# Service Bulletin

NO. 335

SOUTH BEND 27, INDIANA

Fig. 3

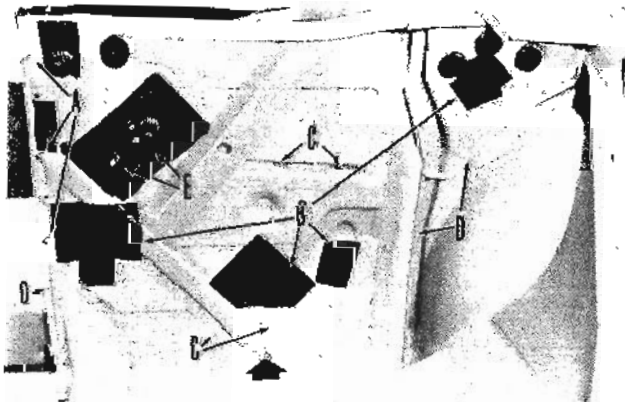
Figure 3 illustrates the rear quarter inner panel of the J Models and points at which leakage may occur.

A. Seal the top and bottom windlace lanced retainers with DUM DUM from inside the quarter panel. Place tape over the center lanced hole from outside and seal with DUM DUM. The holes

in the panel between the windlace retainers should also be sealed with DUM DUM, but from the outside.

B. Make sure that the tape seals-off the opening completely. Replace the tape, if required. If not, seal the edge of the tape with a suitable sealer.

C. Use a suitable sealer on the edges of the reinforcement channels and arm rest nuts.

To prevent water from building up within the reinforcement channels, drill a 1/4" hole, at the approximate location shown in Fig. 3, through the lower reinforcement and the inner body panel to provide a drain. Be sure to seal the hole in the reinforcement channel after drilling.

D. At the pinch weld seams or panel joints force a suitable sealer as far as possible into the seam.

E. Seal around the regulator mounting plate and shaft and, window run channel retaining screws with DUM DUM.

Fig. 5

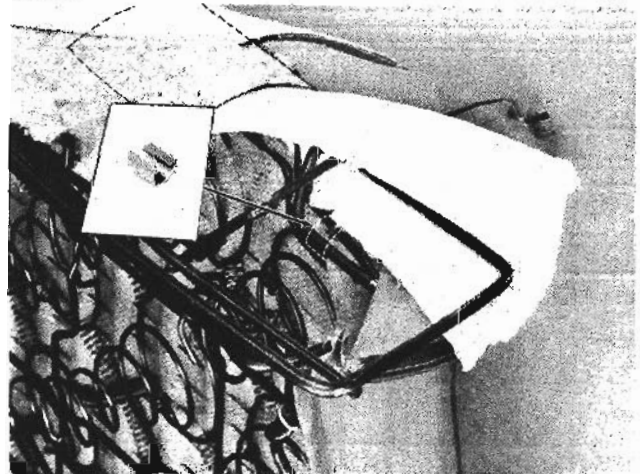
When this condition is found remove the hog rings from the cushion cover and uncover the spring assembly as shown in Fig. 5 or as required.

To correct the fore and aft movement, install a second clip as indicated in Fig. 5. This clip may be fabricated from a piece of sheet metal (3/64" x 5/8" x 1-5/8") or the two wire frame members may be taped together securely. Make sure that the flat side of the top rim wire is directly on top of the round frame member.

To correct the irregular appearance along the side rear top edge of the cushion trim cover, fold the padding and/or sponge rubber from the cushion cover in the area indicated by the dotted lines in Fig. 5 and extend it rearward. Then secure it to the assembly with hog rings. Use two hog rings on the top and one on the rear edge of the frame.

Fig. 6

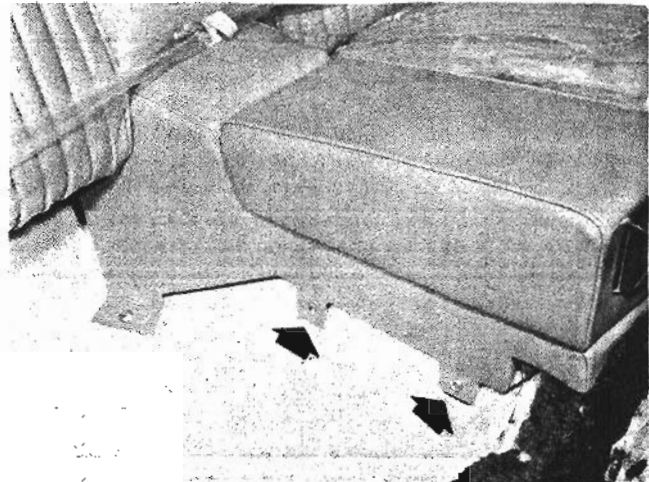
In early production 58L K9 models, the screws which attach the center arm rest to the floor pan at the right side (see Fig. 6) may extend through far enough to cause interference with the propeller shaft.

To prevent this interference, remove the two screws and drill out the two holes to take 3/16" bolts. Install the bolts from below, with the heads of the bolts on the underneath side of the floor pan. Install lock washers and nuts on the bolts and when properly tightened, cut off the end of the bolt flush with the nut. It is only necessary to remove the right side cushion to perform this operation.

On present production models extensions have been welded to both right side center arm rest securing tabs which lowers the screws approximately 1-23/32" on the floor pan from the position illustrated in Fig. 6. On models with the extensions no changes are required, as this new position provides sufficient clearance between the screws and the propeller shaft.

Fig. 7

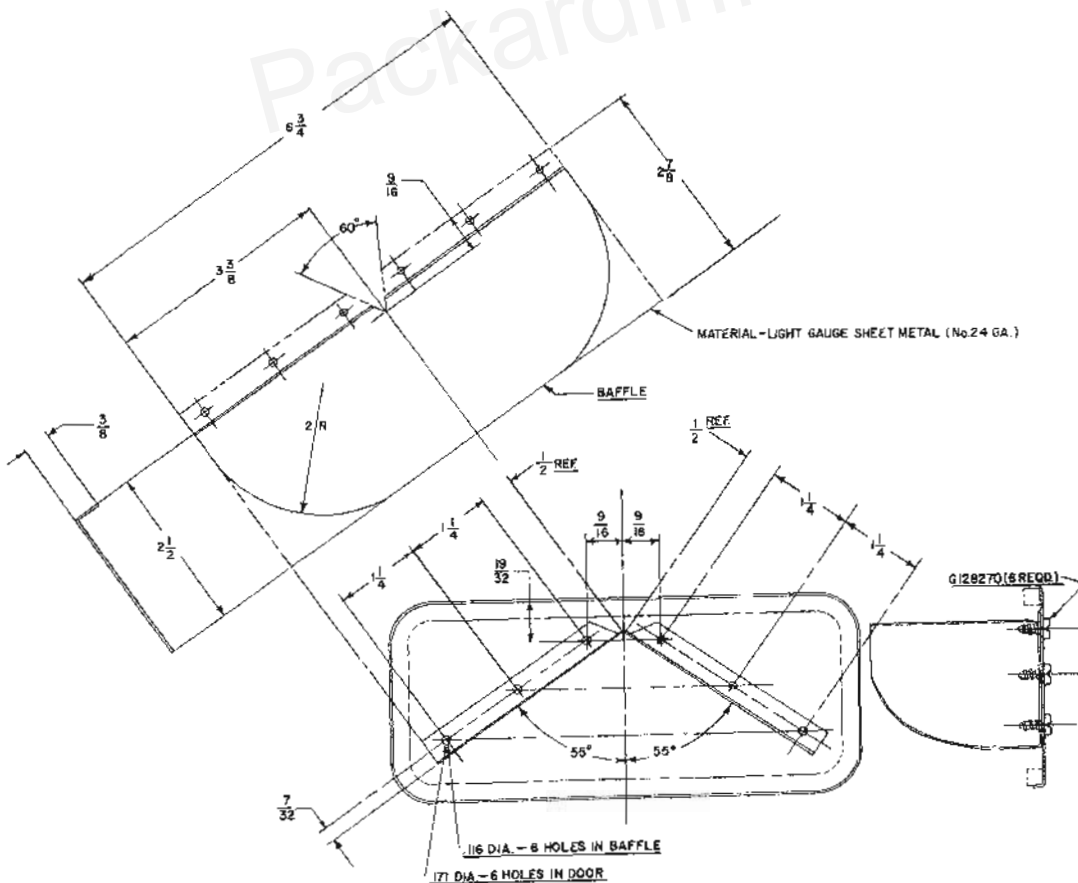
We have received occasional complaints on trucks equipped with a Climatizer, that too much heat is directed onto the driver's foot and not enough heat to the passenger side of the cab. A baffle, which can be readily made in your shop, can be installed on the Climatizer door to divide the air flow so that more heated air is deflected to the passenger side of the cab. The dimensions and the installed position of the baffle are shown in Fig. 7.
